Recommendation to Hold a Public Hearing and Approve the Doughty Lot Line Shift Final Plat

A LOT LINE SHIFT PLAT SHOWING LOTS 10A & 11A, GOLFVIEW SUBDIVISION NO. 1

IN RE:)
)
 Doughty Lot Line Shift) **KETCHUM CITY COUNCIL**
 Readjustment of Lot Lines Final Plat) **FINDINGS OF FACT, CONCLUSIONS OF LAW, AND**
 Date: December 2, 2019) **DECISION**
)
 File Number: 19-115)

PROJECT: Doughty Lot Line Shift

A LOT LINE SHIFT PLAT FOR
LOTS 10A & 11A
GOLFVIEW SUBDIVISION NO. 1

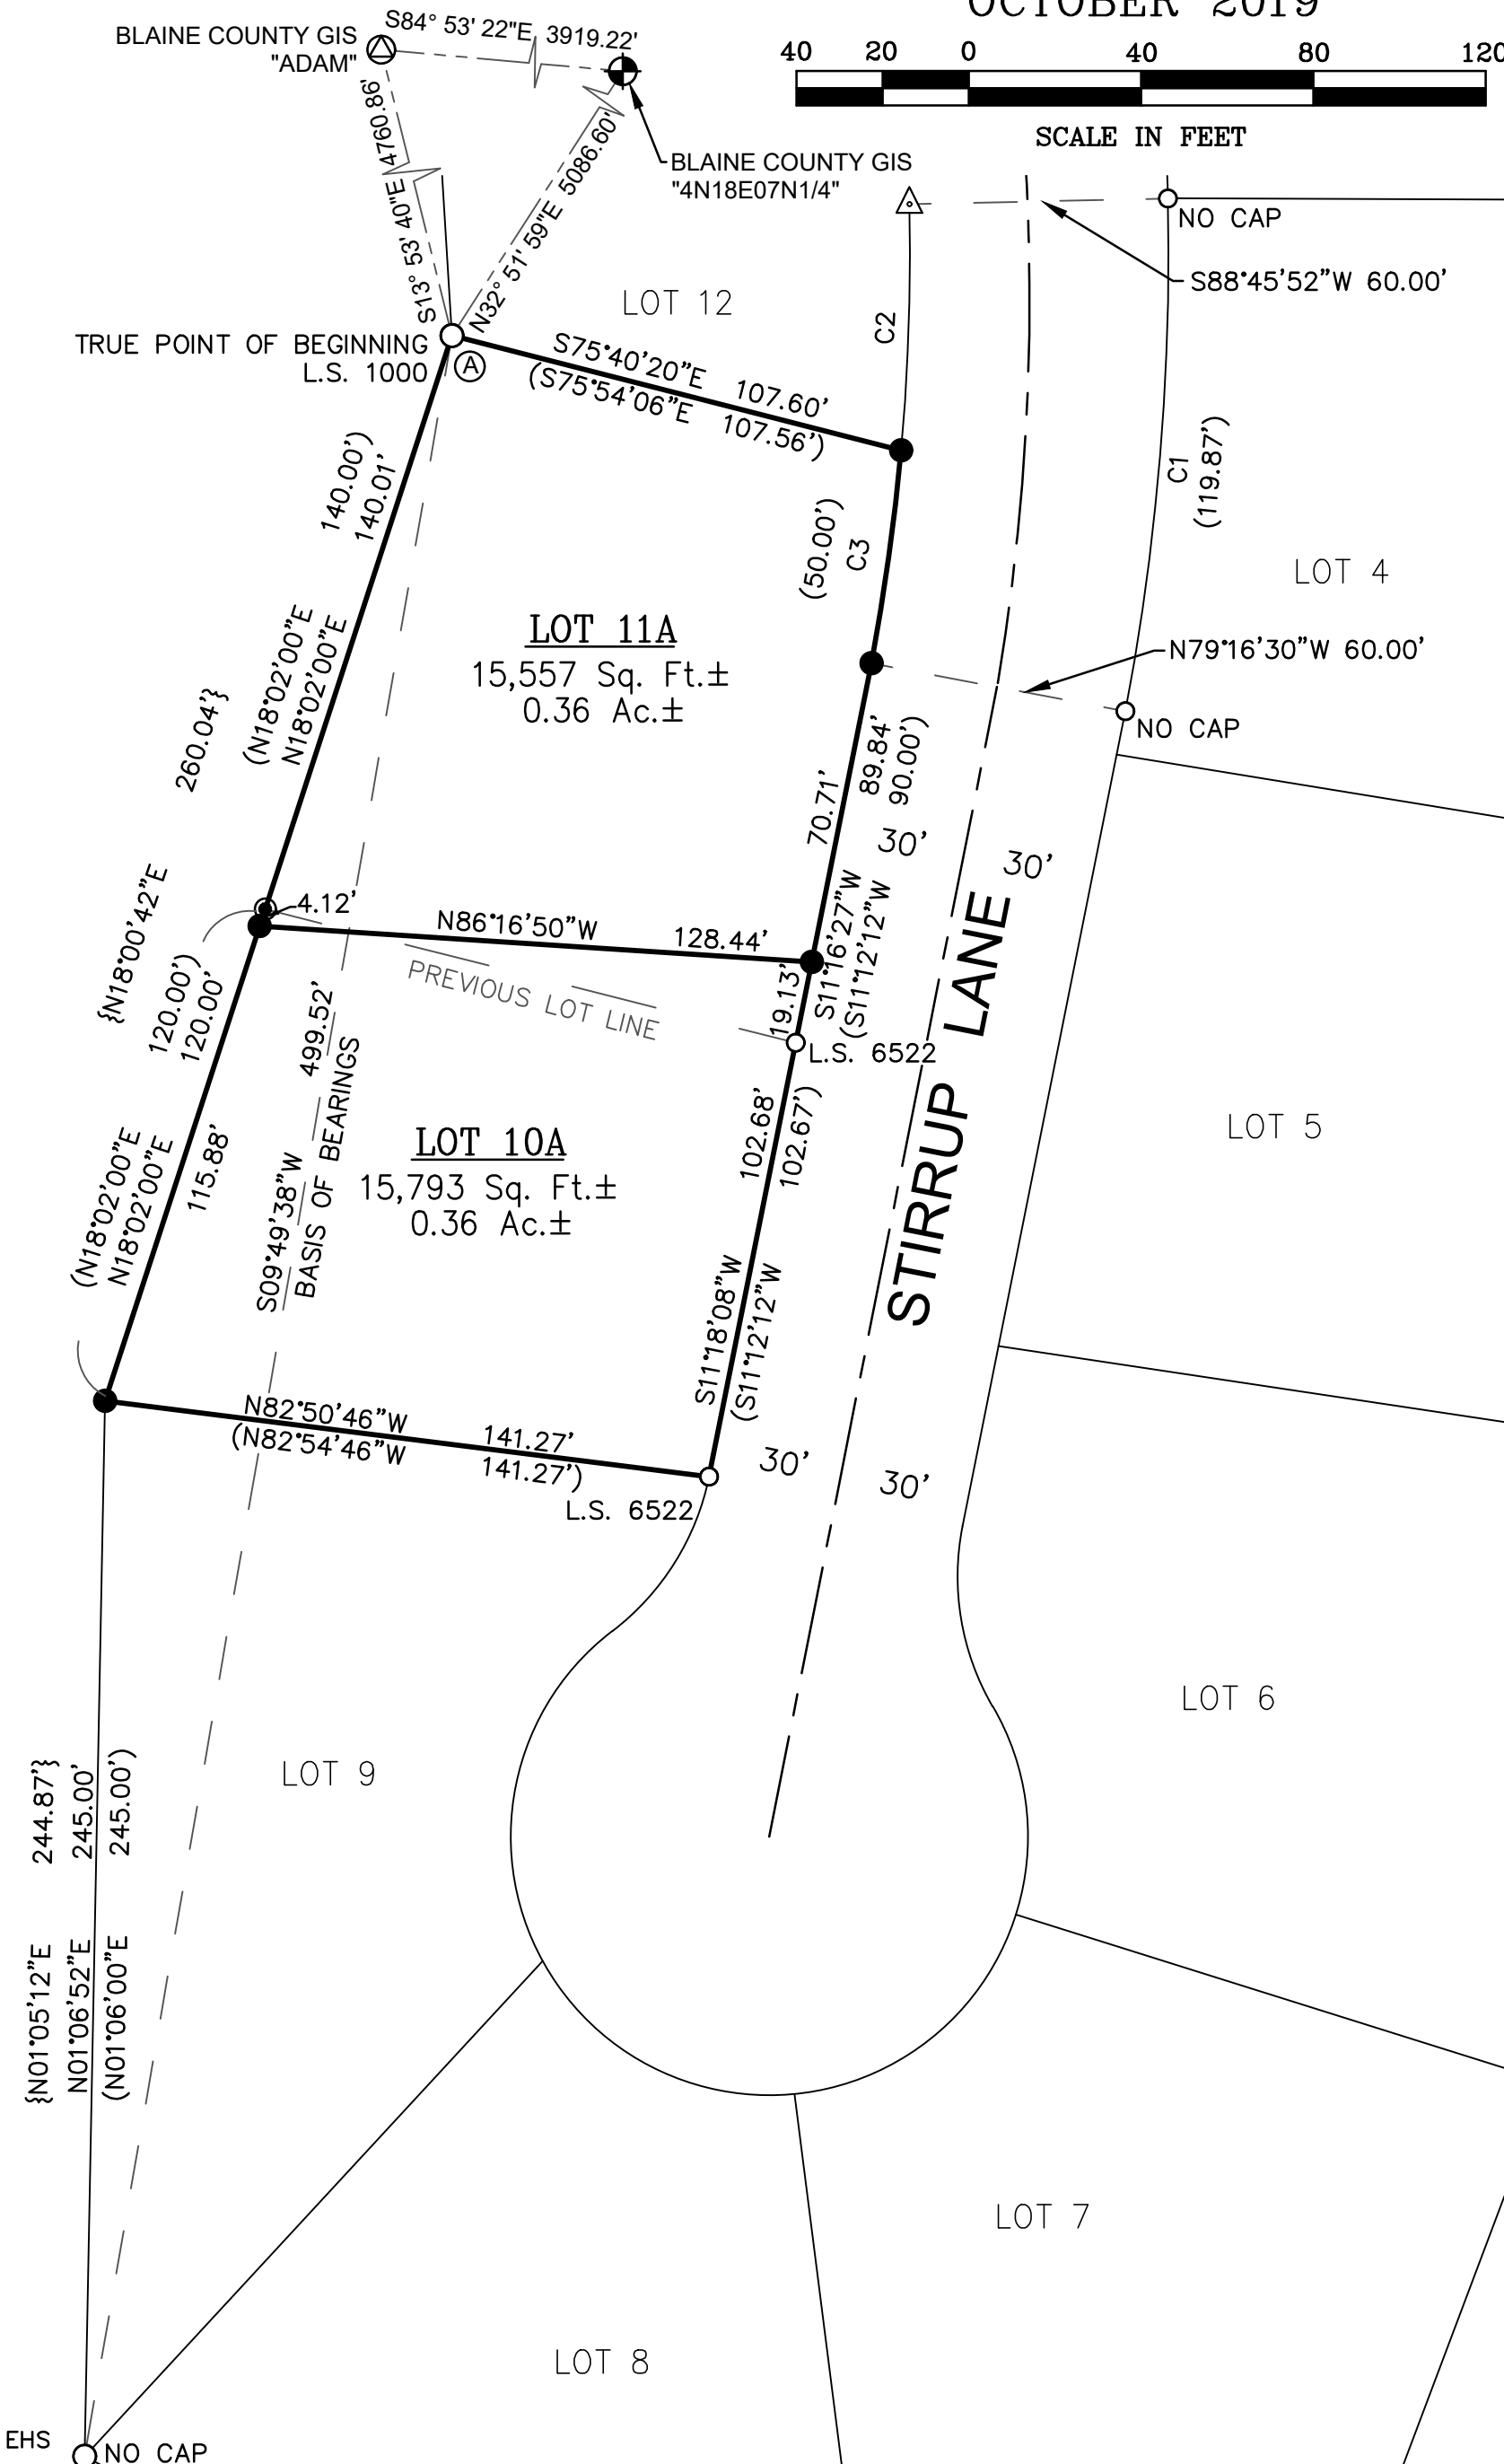
Lot 10 is currently 14,823 square feet and Lot 11 is currently 16,478 square feet. The lot line shift will move the interior property line northward resulting in a Lot 10A that is 15,893 square feet and a Lot 11A that is 15,557 square feet.

Both lots 10A and Lot 11A will conform to zoning regulations in terms of minimum lot size, setbacks, and lot coverages for the GR-L zoning district. The interior lot line will move closer to the existing residence on Lot 11, but a setback exceeding 15' will be maintained.

City Council Findings	<i>This standard has been met. The name of the proposed subdivision is "A Lot Line Shift Plat Showing Lots 10A and 11A, Golfview Subdivision No. 1"</i>
<input checked="" type="checkbox"/>	<input type="checkbox"/>	<input type="checkbox"/>	16.04.030.K.10	Scale, north arrow and date.
			City Council Findings	<i>This standard has been met.</i>
<input checked="" type="checkbox"/>	<input type="checkbox"/>	<input type="checkbox"/>	16.04.030.K.11	Location, width, and names of all existing or dedicated streets and other public ways within or adjacent to the proposed subdivision
			City Council Findings	<i>This standard has been met.</i>
<input checked="" type="checkbox"/>	<input type="checkbox"/>	<input type="checkbox"/>	16.04.030.K.12	A provision in the owner's certificate referencing the county recorder's instrument number where the condominium declaration(s) and/or articles of incorporation of homeowners' association governing the subdivision are recorded.

1. The recorded plat shall show a minimum of two Blaine County Survey Control Monuments with ties to the property and an inverse between the two monuments. The Survey Control Monuments shall be clearly identified on the face of the map.

7. The Final Plat mylar shall contain all items required under Title 50, Chapter 13, Idaho Code as well as all items required pursuant to KMC §16.04.030J including certificates and signatures.
